KITCHENER-WILMOT HYDRO INC.

RESPONSES TO PRE-SETTLEMENT CLARIFICATION QUESTIONS

SEPTEMBER 13, 2019

**2020 Electricity Distribution Rates Application
Kitchener-Wilmot Hydro Inc. (Kitchener-Wilmot)
EB-2019-0049**

Figure 1 : Hyper Converged IT infrastructure Diagram

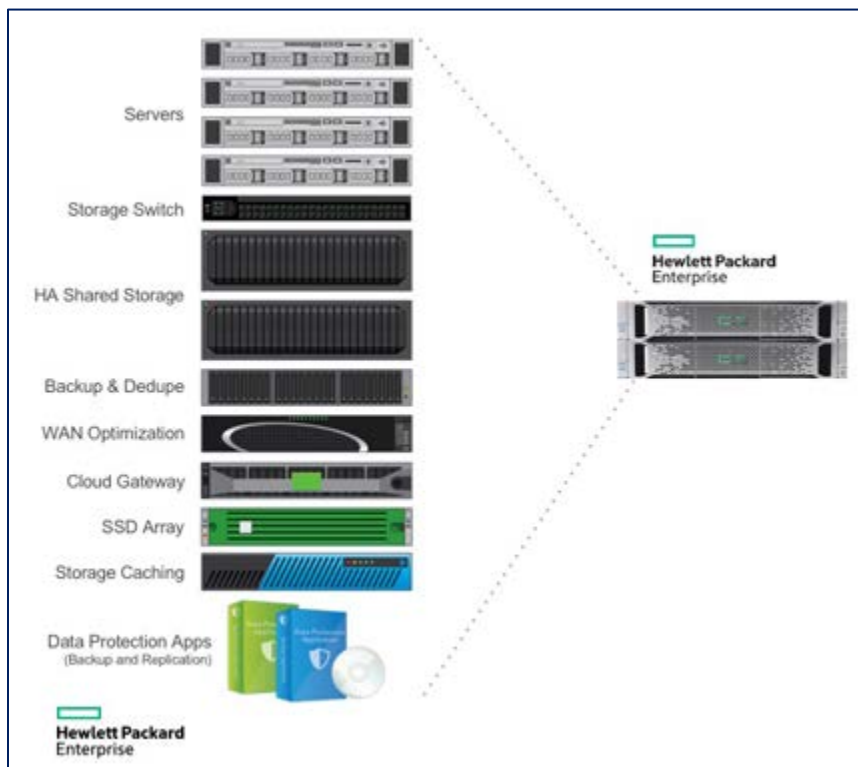
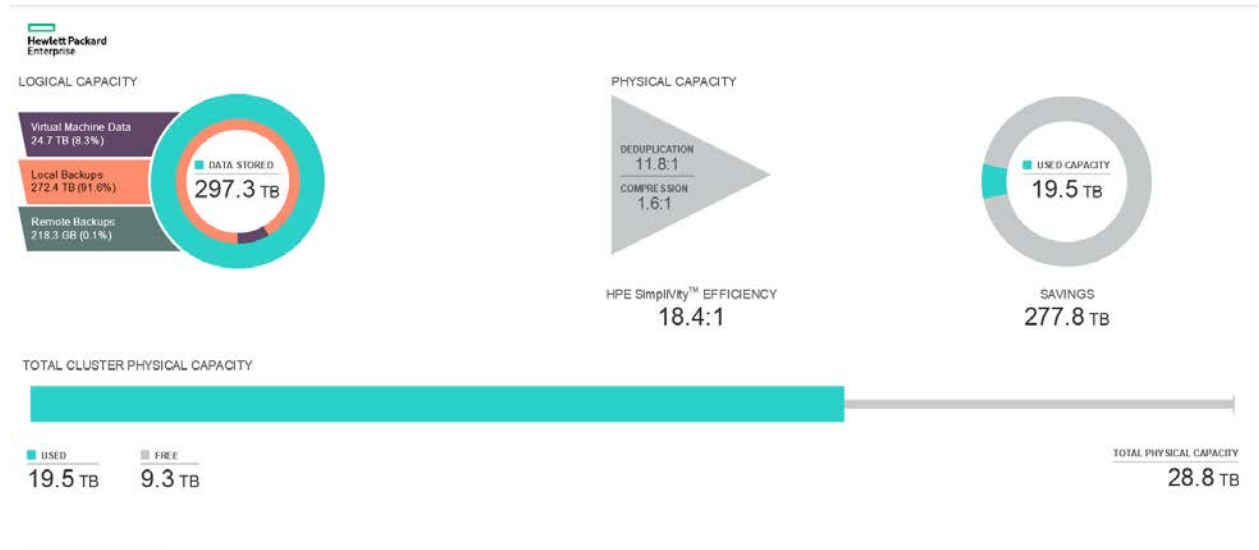
Information Technology

Ref: 2-Staff-9

Kitchener-Wilmot stated that it evaluated the current technologies available for server infrastructure and decided to move to a hyperconverged infrastructure with built-in data duplication to reduce the requirements for physical storage and significantly improve data recovery during disasters.

- a) Please explain what is “hyperconverged infrastructure with built-in data duplication” and the different capabilities it offers from the existing infrastructure?

Hyper converged infrastructure (HCI) provides compute (server), storage, networking, virtualization, backup, and disaster recovery resources that are all managed by software instead of being separate entities as shown in Figure 1 below (excerpt from Hewlett Packard Enterprise – infrastructure currently being used by KWHI). It also has inline data deduplication (eliminates redundant data) that reduce the amount of physical data storage required in a traditional IT environment. See Figure 2 below that shows data capacity being saved in KWHI’s current environment.

The image below shows that KWHI’s current environment using HCI is reducing stored capacity at a rate of approximately 18:1. That is, 297.3TB of logical data available in our

production environment while only 19.5 TB is written to disk using HCI deduplication and compression.
